The purpose of this amendment is to respond to questions received from prospective bidders (See pages 2-6) and two drawings (pages 7-8). The response date to submit quotes of July 30, 2008 remains unchanged.

Solicitation Number: NNK08257702Q

Project Title: Refurbish and Install Mercury Redstone Rocket at New KSC Pass & ID Bldg.

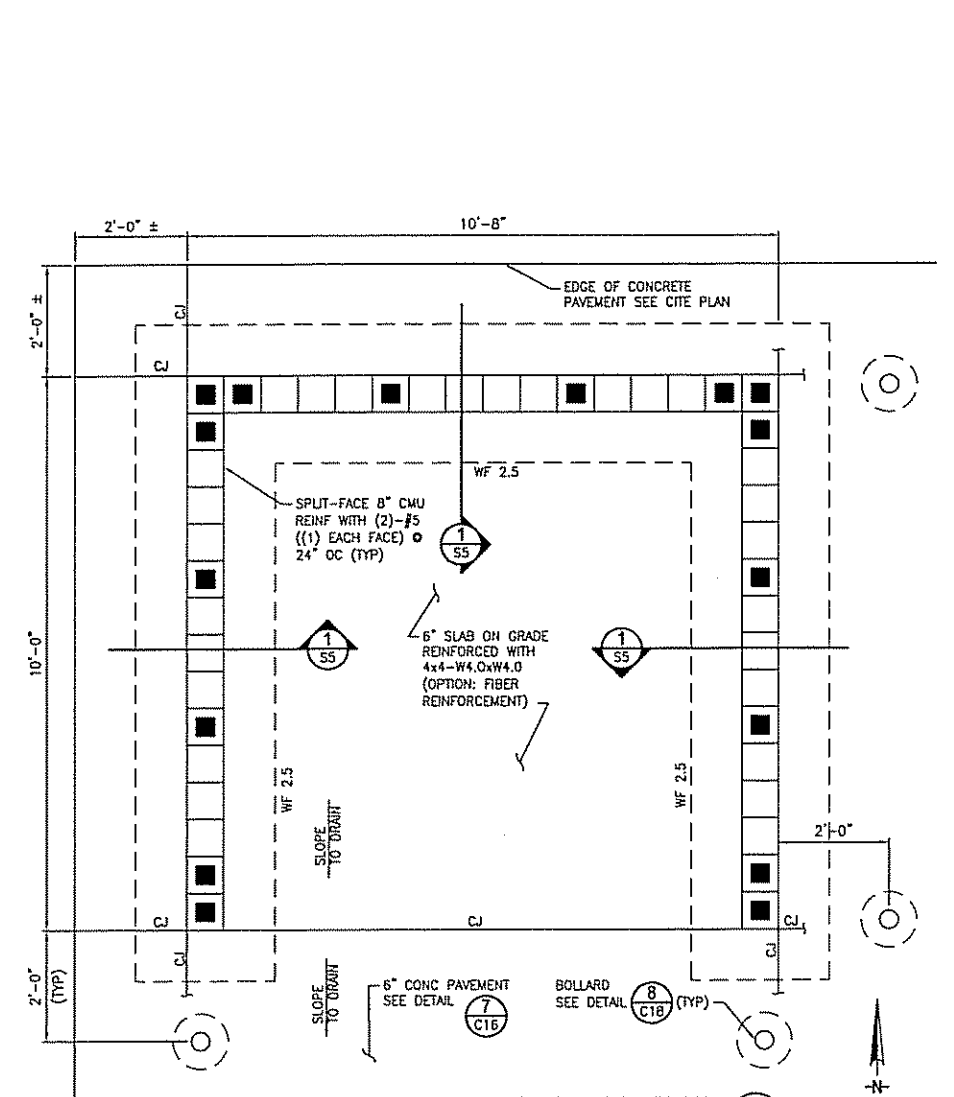
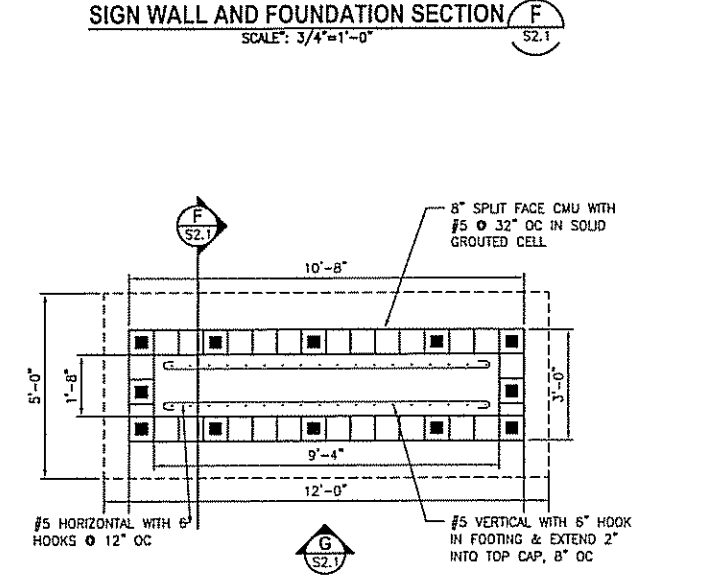
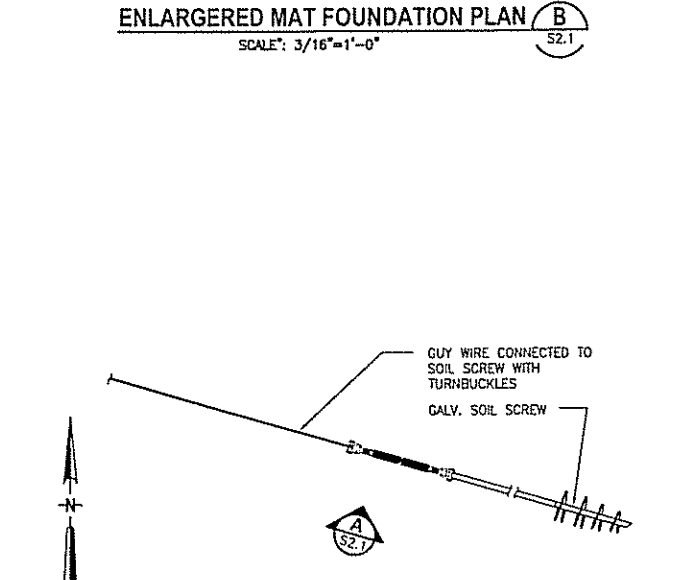
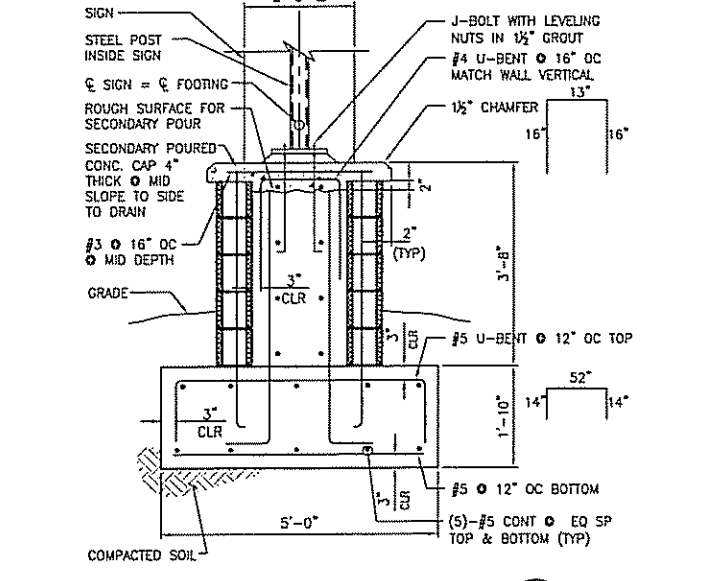
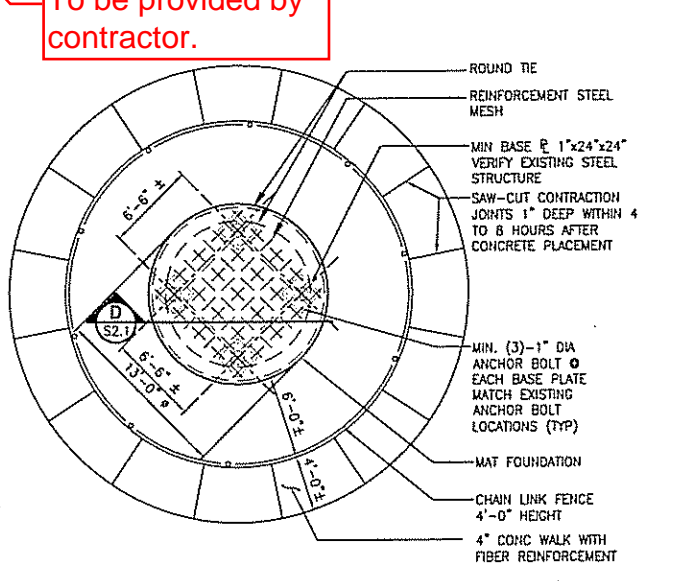
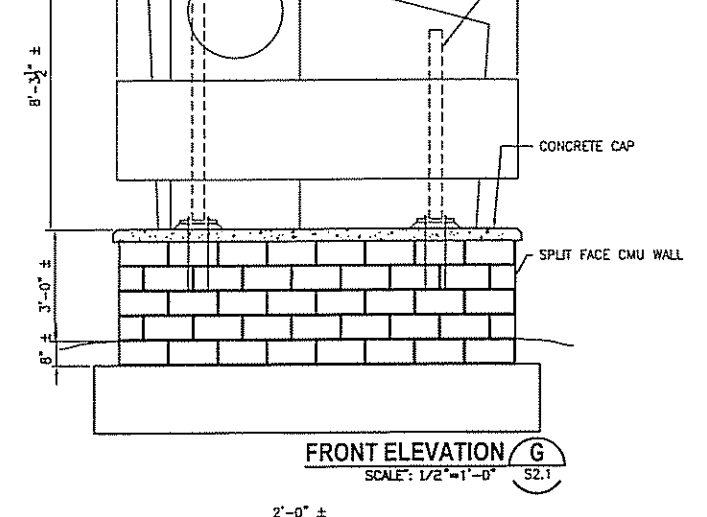
Q3. Are the 3 guide wires going to be attached to the rocket at the new pass & ID, if so is new wire rope required?

Q38. There appear to be no tiedown cable attachments at the new 405 site. Will anchors or other ground attachment points be provided by NASA or will this be part of the work scope?

A38. The contractor shall provide the guy wire (6X19-7/16" dia stainless steel wire rope) and galvanized soil screw (30 ft. long with 1 3/4" square shaft & 4 helix plates. Also a galvanized turn buckle with jaw and jaw end and 1 1/4 in. dia threaded rod shall be used. See attached drawing for detail installation dimensions.

This base is not the one to be used. J bolt locations, though, remain per the drawing. Contractor to verify. Create leg bolt patterns on new leg plates for base being used.

NOTE: MAT FOUNDATION IS DESIGNED FOR SERVICE LOAD WITH GUYWIRE AND ANCHORS INSTALLED. ROCKET MODEL SHALL BE STABILIZED BY SHORING BEFORE GUYWIRE AND ANCHOR INSTALLATION.
